**C-18 McCullough Avenue Sewer Replacement Project**  
**Solicitation Number: CO-00390-SM**  
**Job No.: 17-4555**

**ADDENDUM 2**  
**December 17, 2020**

SHEET NO. **C-14**  
 32 OF 74

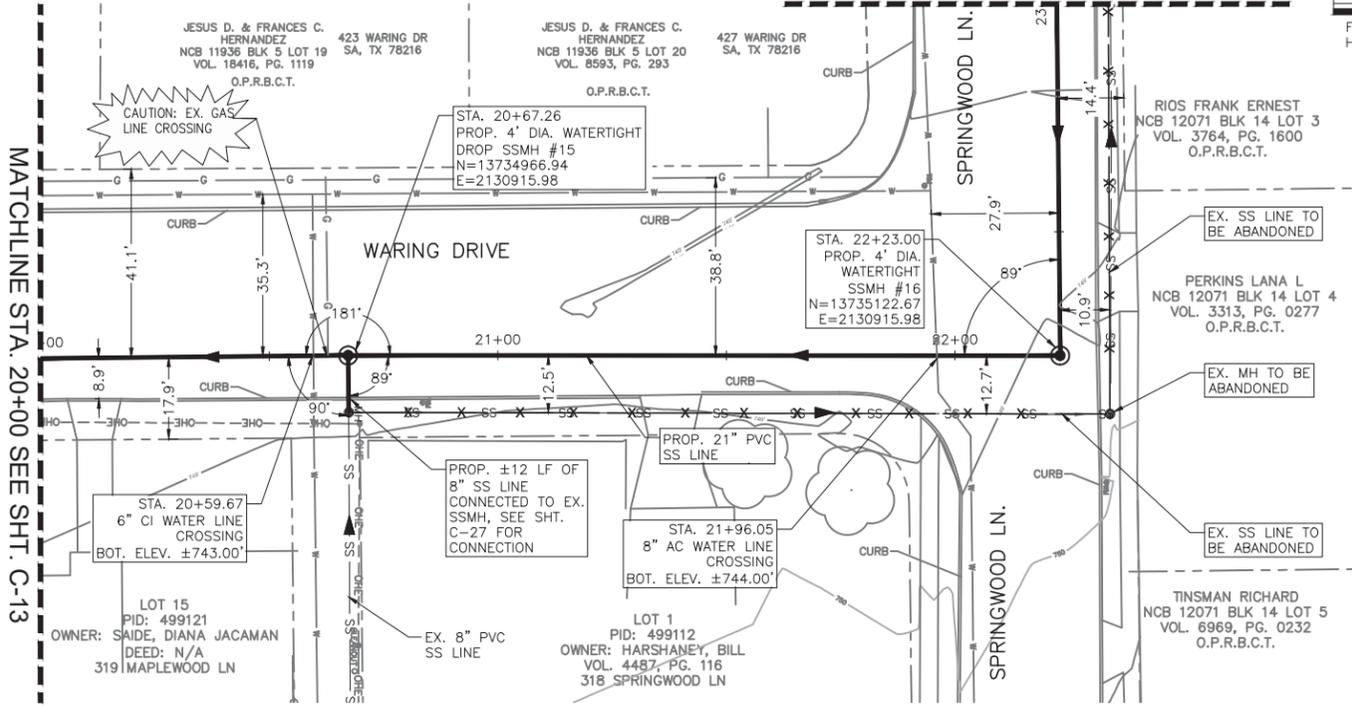
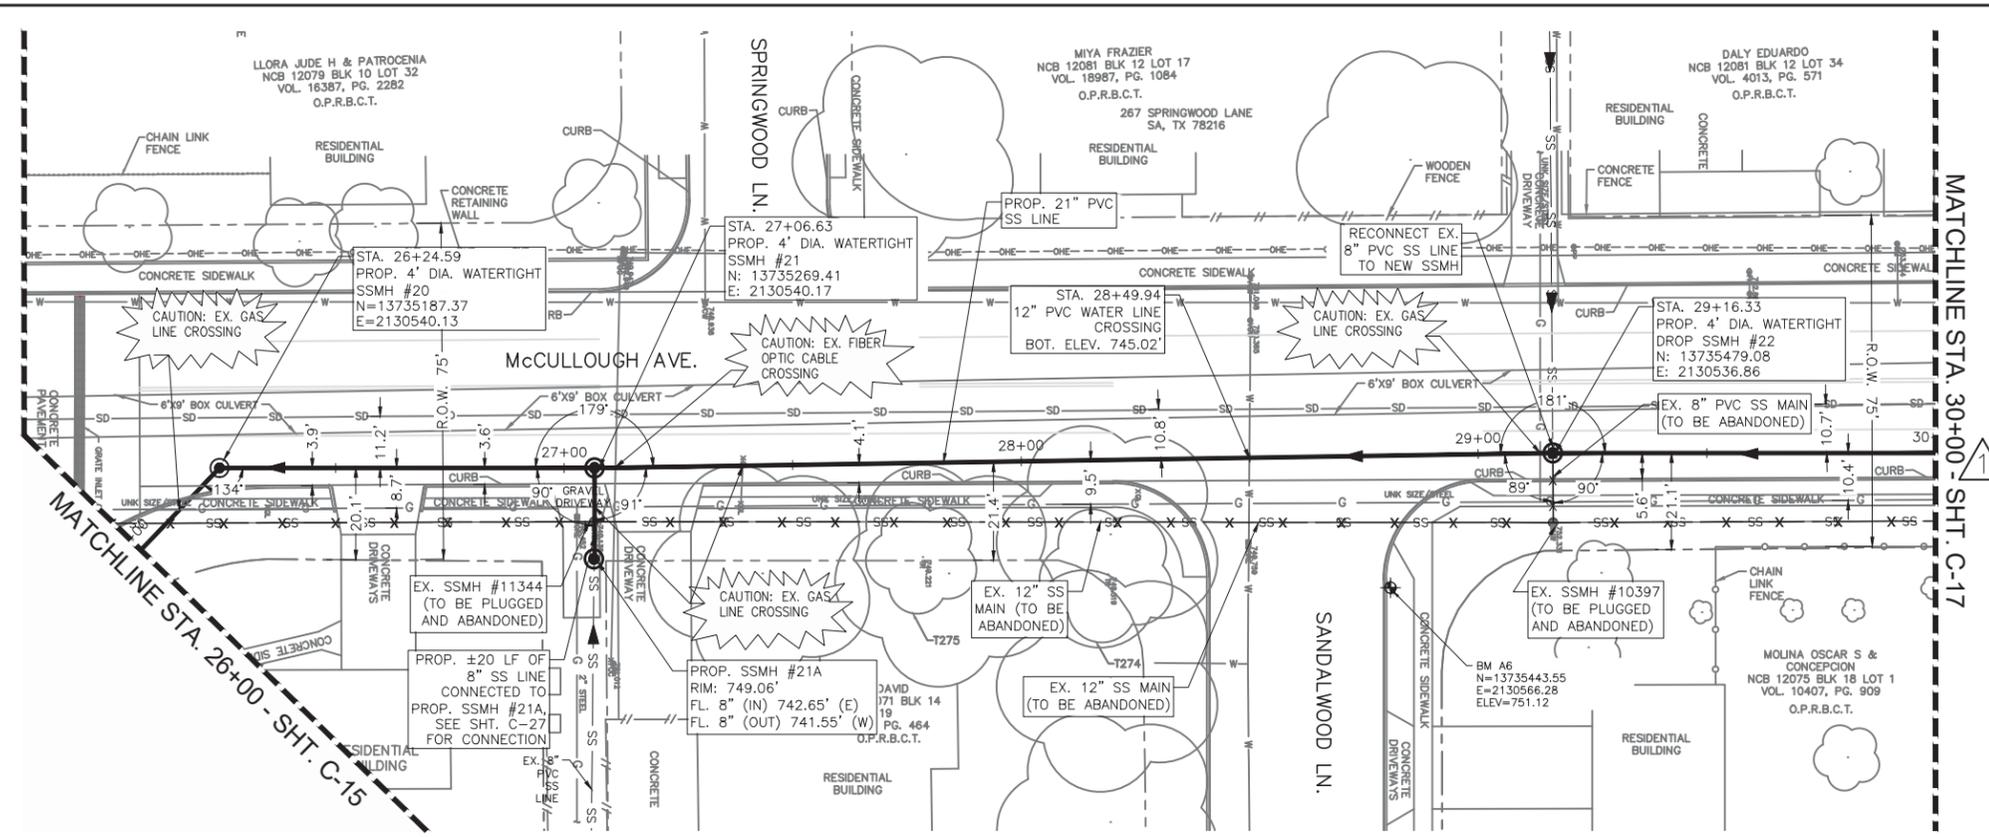
7. Plan Sheet C-14: Line item “858 concrete encasement, cradles, saddles” is removed in its entirety. Concrete encasement, saddles, cradles and collars shall be subsidiary to pipe installed. No separate pay item. Cement Stabilized Sand shall be in compliance with TCEQ Code 217.53(d)(7)(D)(i) and shall be subsidiary to pipe installed. No separate pay item for cement stabilized sand.

SHEET NO. **C-16**  
 34 OF 74

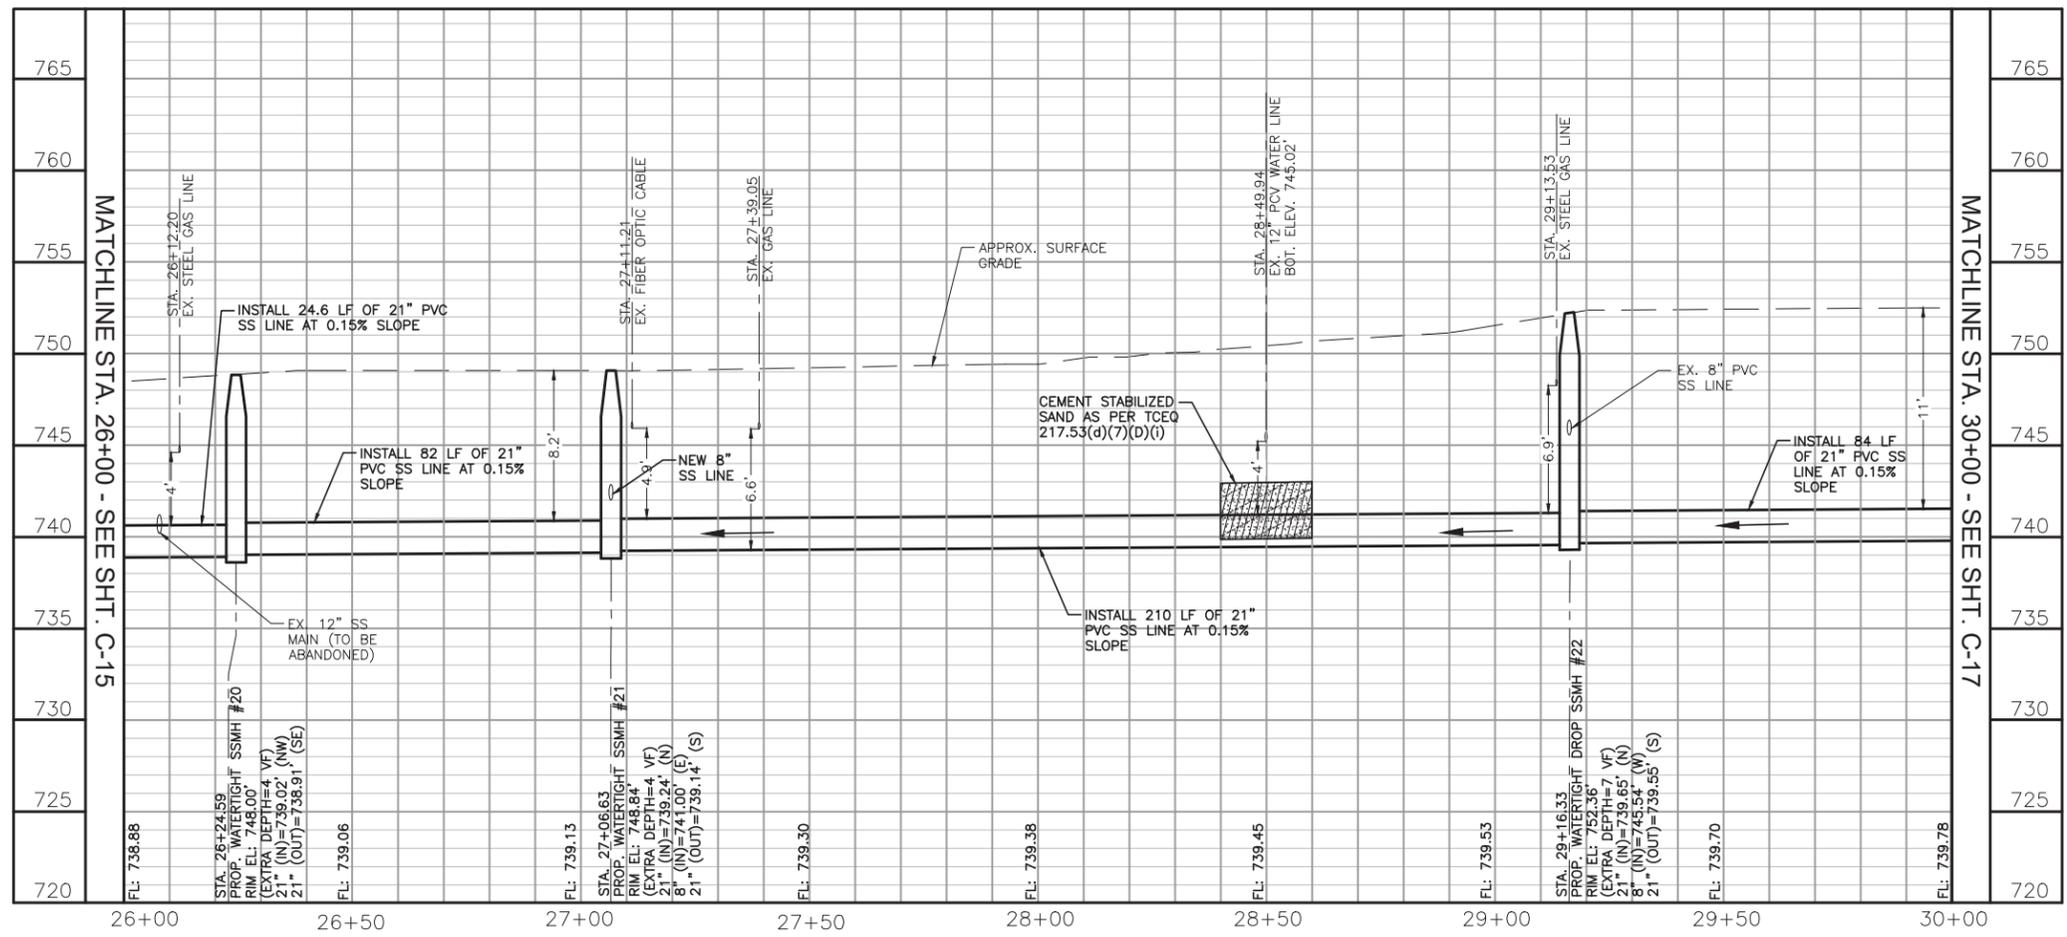
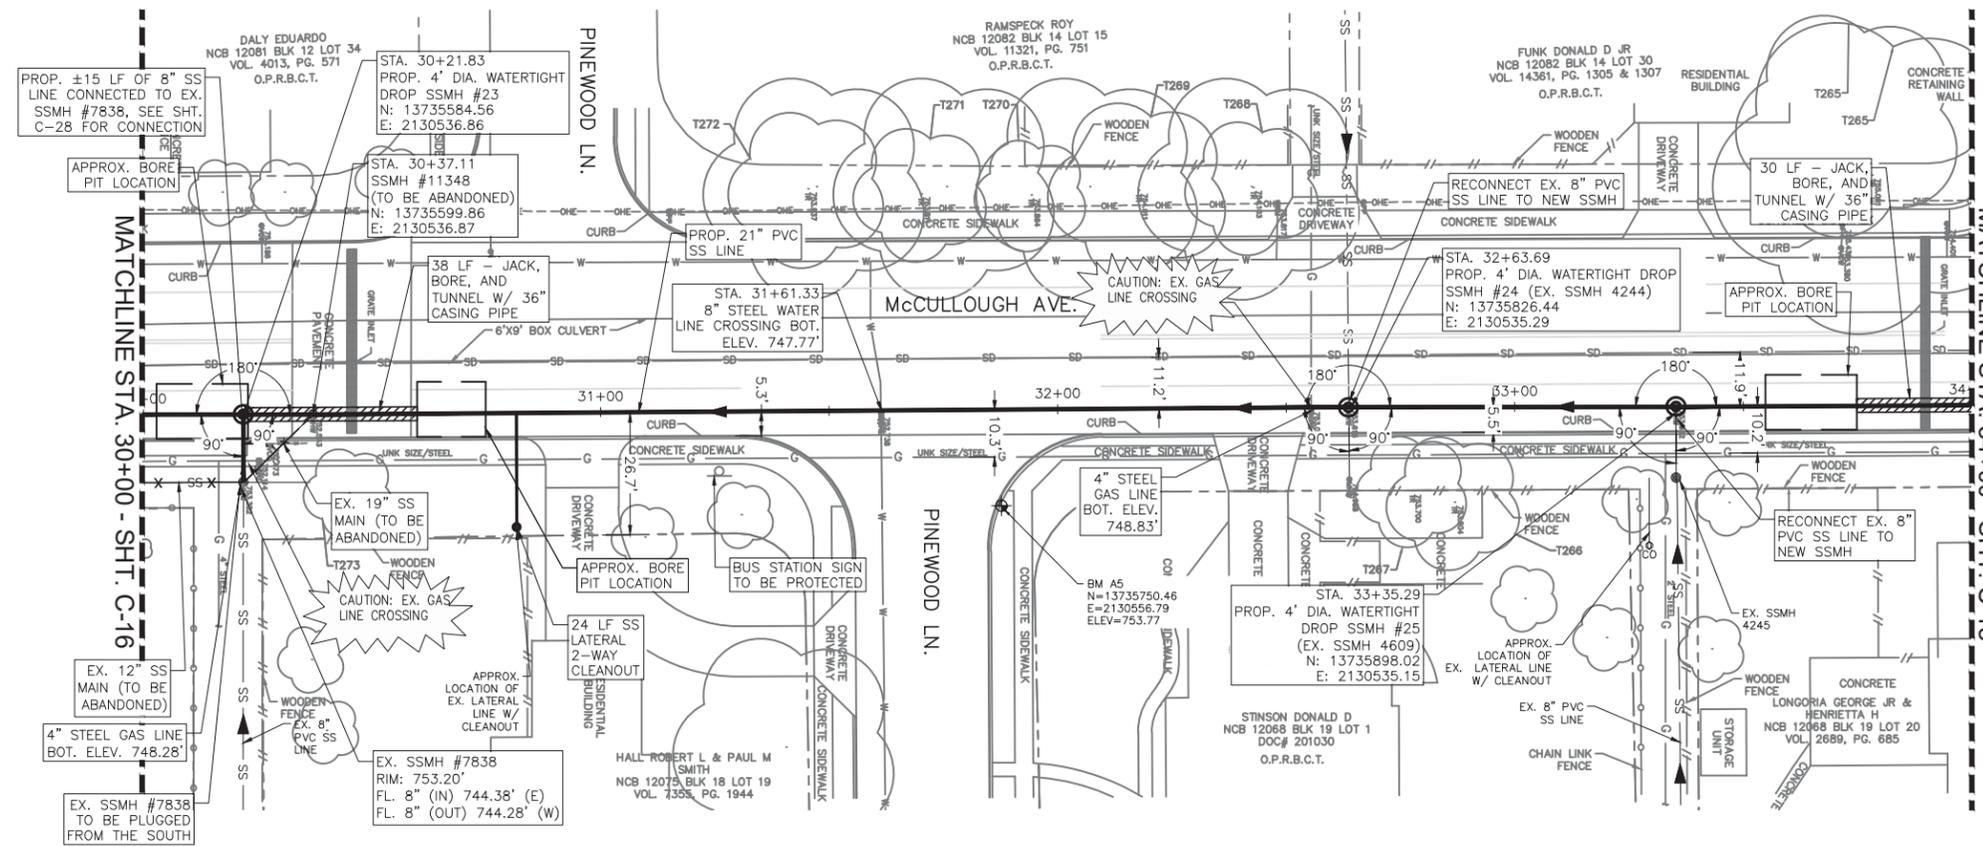
8. Plan Sheet C16: Line item “858 concrete encasement, cradles, saddles” is removed in its entirety. Concrete encasement, saddles, cradles and collars shall be subsidiary to pipe installed. No separate pay item. Cement Stabilized Sand shall be in compliance with TCEQ Code 217.53(d)(7)(D)(i) and shall be subsidiary to pipe installed. No separate pay item for cement stabilized sand.

SHEET NO. C-17  
 35 OF 74

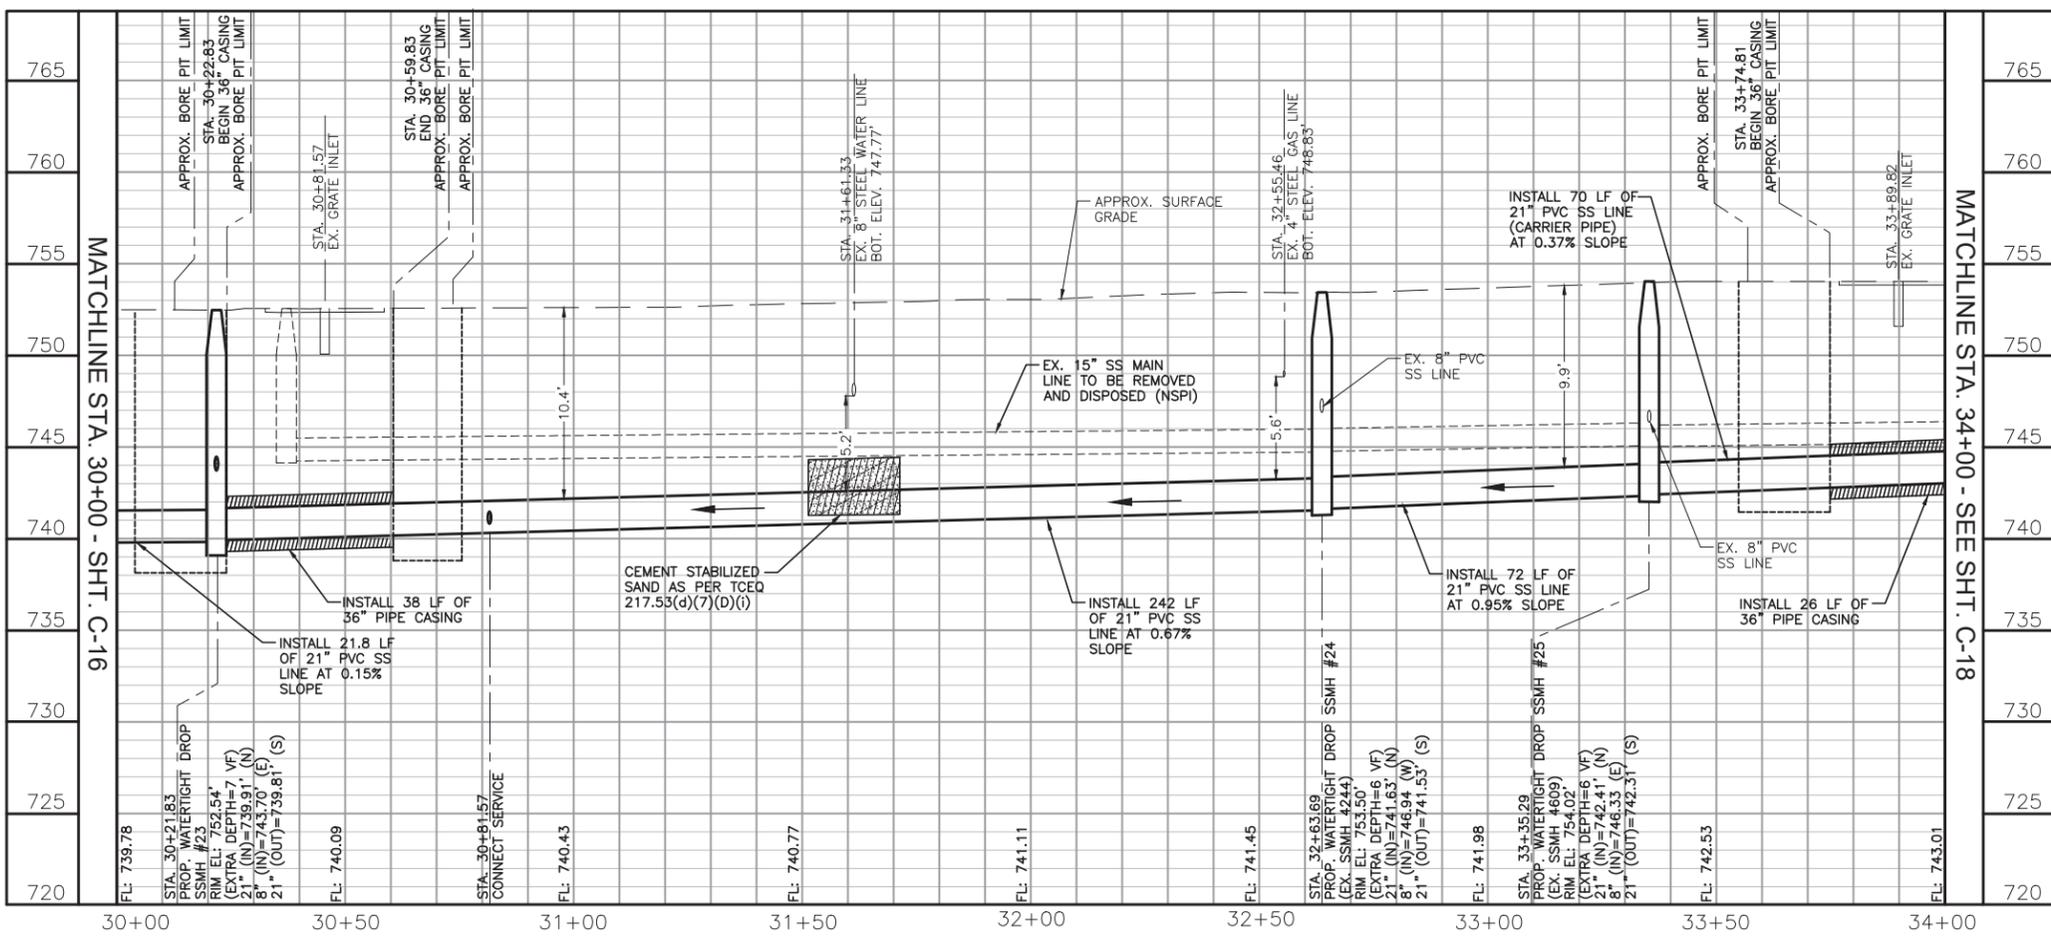
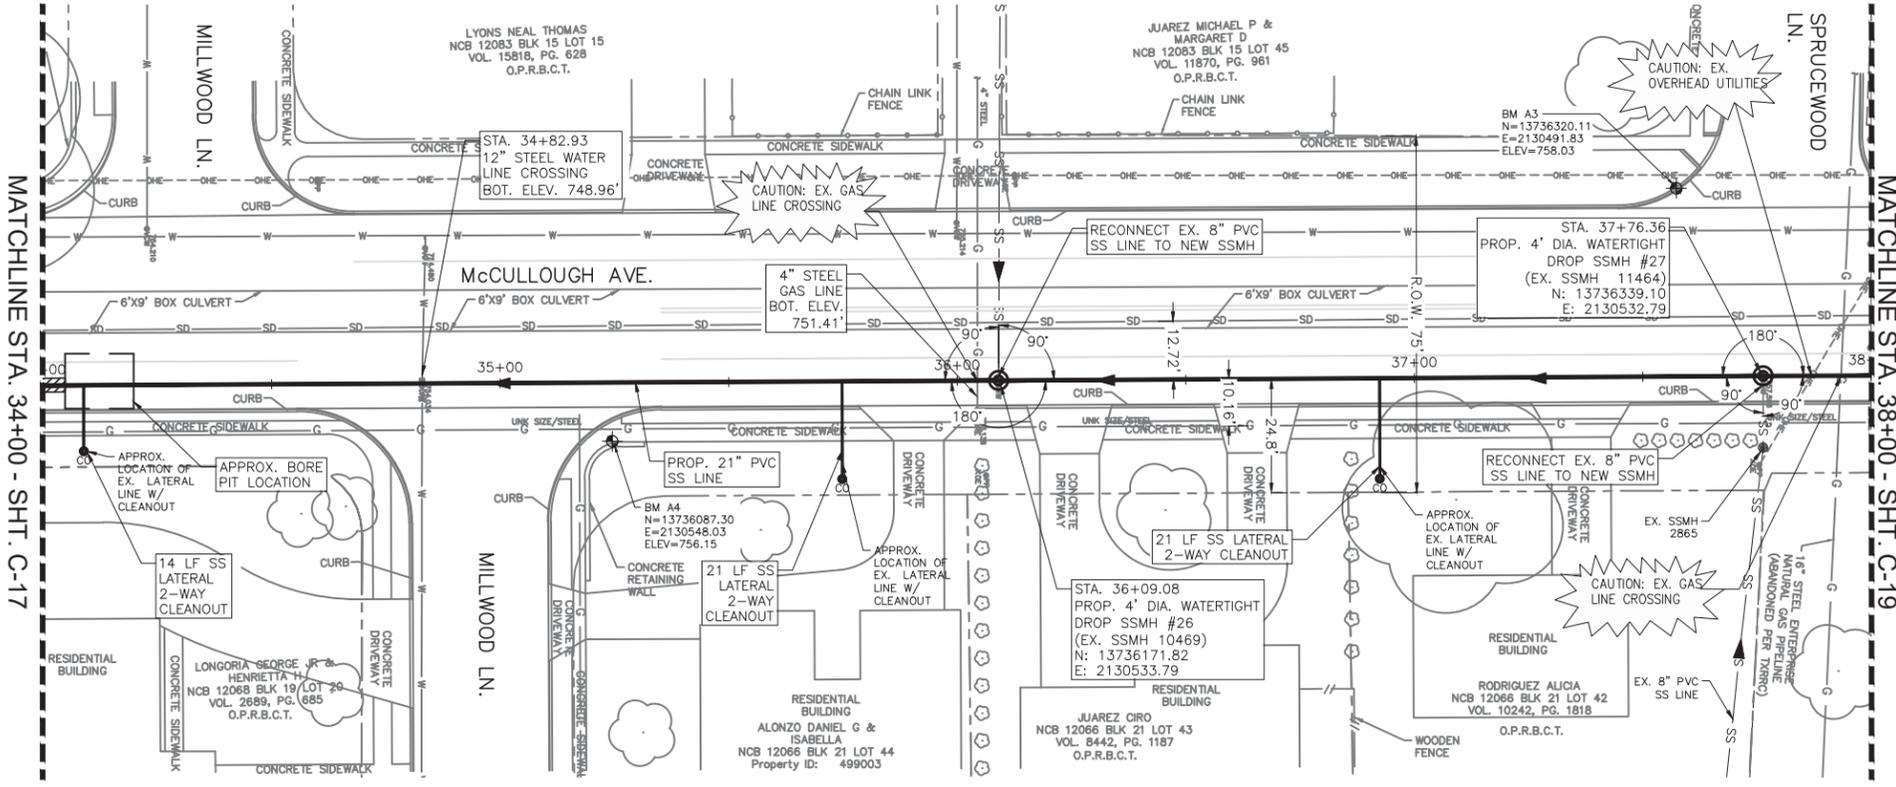
9. Plan Sheet C-17: Line item “858 concrete encasement, cradles, saddles” is removed in its entirety. Concrete encasement, saddles, cradles and collars shall be subsidiary to pipe installed. No separate pay item. Cement Stabilized Sand shall be in compliance with TCEQ Code 217.53(d)(7)(D)(i) and shall be subsidiary to pipe installed. No separate pay item for cement stabilized sand.
